# HISTORIC AND DESIGN REVIEW COMMISSION

October 06, 2021

**HDRC CASE NO:** 2021-453  
**ADDRESS:** 302 FURR DR  
**LEGAL DESCRIPTION:** NCB 6695 BLK 4 LOT 28  
**ZONING:** R-6, H  
**CITY COUNCIL DIST.:** 7  
**DISTRICT:** Monticello Park Historic District  
**APPLICANT:** Arash Pazouki /PEBBLE DAWN PROPERTIES LLC  
**OWNER:** PEBBLE DAWN PROPERTIES LLC  
**TYPE OF WORK:** Window replacement  
**APPLICATION RECEIVED:** August 31, 2021  
**60-DAY REVIEW:** Not applicable due to City Council Emergency Orders  
**CASE MANAGER:** Rachel Rettaliata

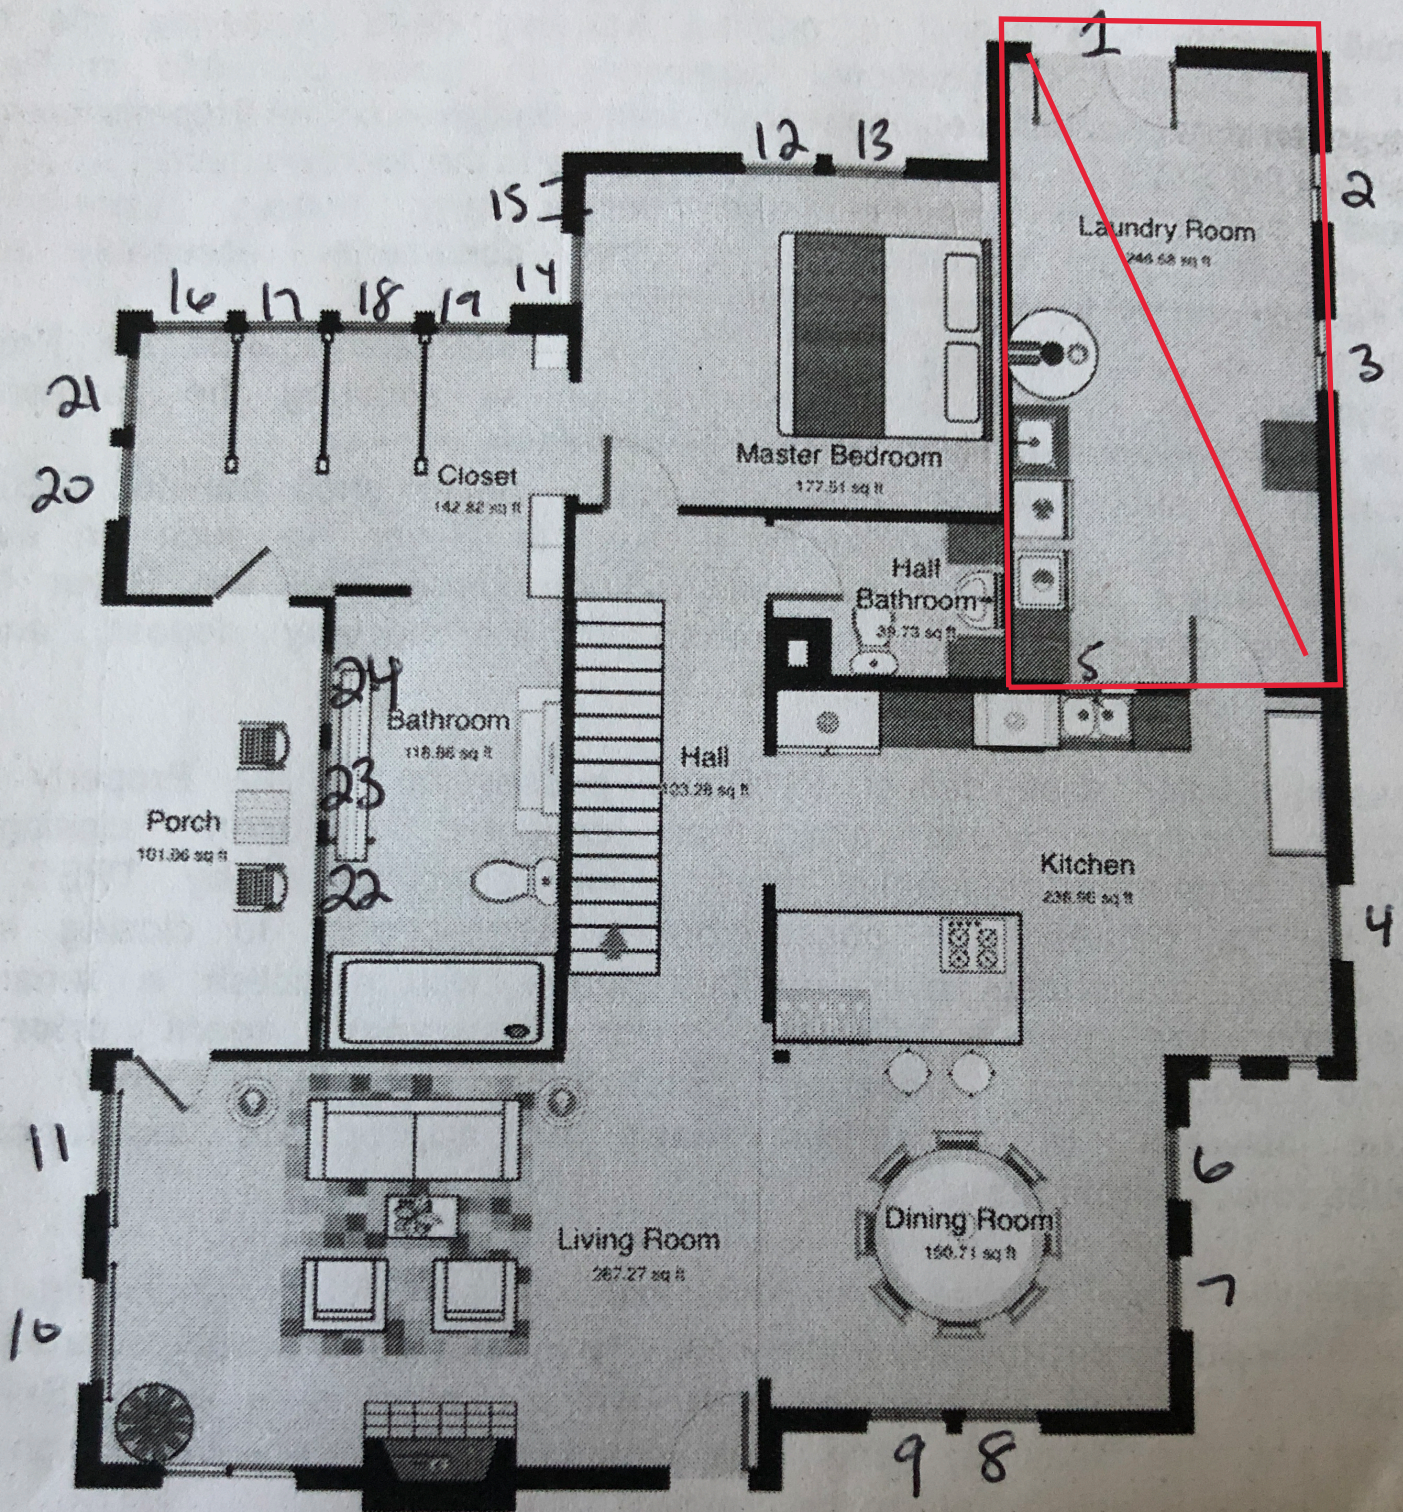
- e. WINDOW REPLACEMENT – The applicant has proposed to replace 30 existing wood windows with replacement aluminum windows in bronze with low-E glass. The existing windows requested for replacement are located on the primary structure, including the front façade, and the rear addition. According to the Historic Design Guidelines, wood windows should be repaired in place and restored whenever possible, unless there is substantial evidence that the windows are deteriorated beyond repair. Guideline 6.B.iv for Exterior Maintenance and Alterations states that new windows should be installed to match the historic or existing windows in terms of size, type, configuration, material, form, appearance, and detail when original windows are deteriorated beyond repair. As noted in finding b, staff finds that the windows are in repairable condition, with a majority of

them being covered and protected over the past few decades by exterior screens, and that the replacement product is not appropriate or consistent with the Guidelines.

Item 1, staff does not recommend approval based on findings a through e. The Historic Design Guidelines always recommend that the repair of historic-age windows be prioritized over replacement.

- i. That the applicant installs fully wood windows that meet staff's standard window stipulations and submits updated specifications to staff for review and approval. The windows should feature an inset of two (2) inches within facades and should feature profiles that are found historically within the immediate vicinity. Meeting rails must be no taller than 1.25" and stiles no wider than 2.25". White manufacturer's color is not allowed, and color selection must be presented to staff. There should be a minimum of two inches in depth between the front face of the window trim and the front face of the top window sash. This must be accomplished by recessing the window sufficiently within the opening or with the installation of additional window trim to add thickness. Window trim must feature traditional dimensions and architecturally appropriate sill detail. Window track components must be painted to match the window trim or concealed by a wood window screen set within the opening.

- ii. That the existing wood windows are salvaged and stored on site for future use or donated to a local architectural salvage store.

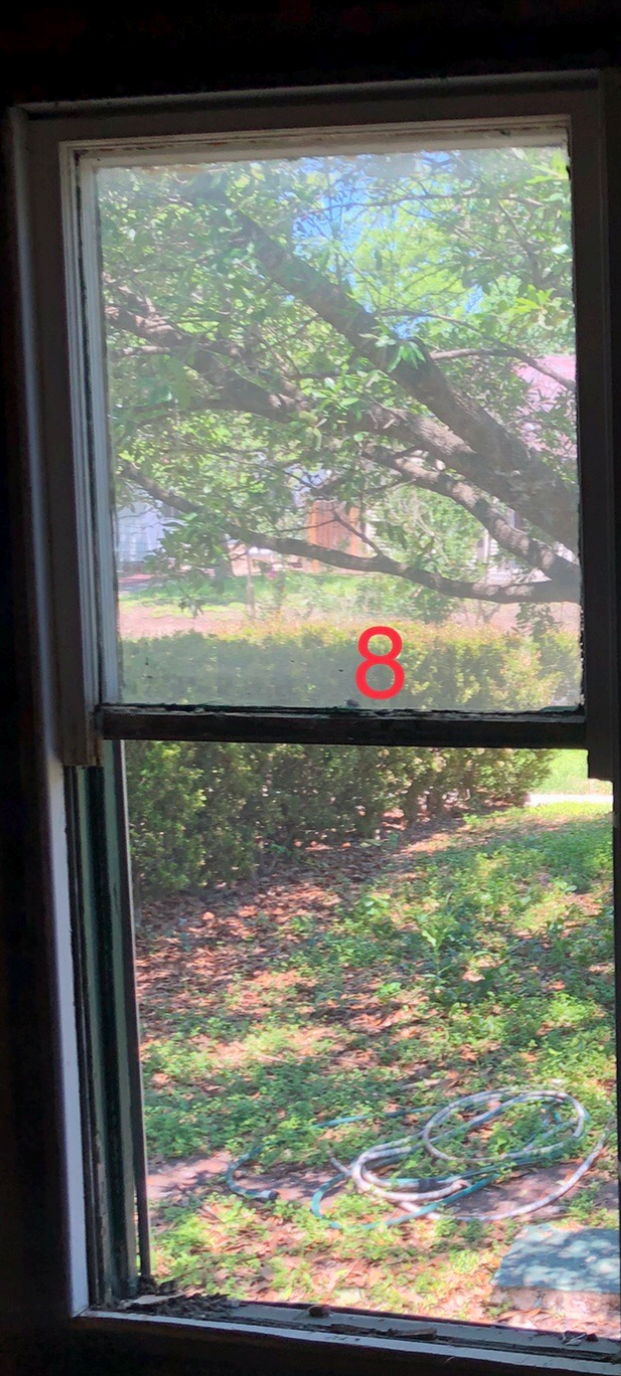
Item 2, staff recommends that the application installs fully wood windows in window openings 6 & 7, which do not currently feature windows, with the following stipulation:

- i. That the applicant installs fully wood windows that meet staff's standard window stipulations and submits updated specifications to staff for review and approval. The windows should feature an inset of two (2) inches within facades and should feature profiles that are found historically within the immediate vicinity. Meeting rails must be no taller than 1.25" and stiles no wider than 2.25". White manufacturer's color is not allowed, and color selection must be presented to staff. There should be a minimum of two inches in depth between the front face of the window trim and the front face of the top window sash. This must be accomplished by recessing the window sufficiently within the opening or with the installation of additional window trim to add thickness. Window trim must feature traditional dimensions and architecturally appropriate sill detail. Window track components must be painted to match the window trim or concealed by a wood window screen set within the opening.
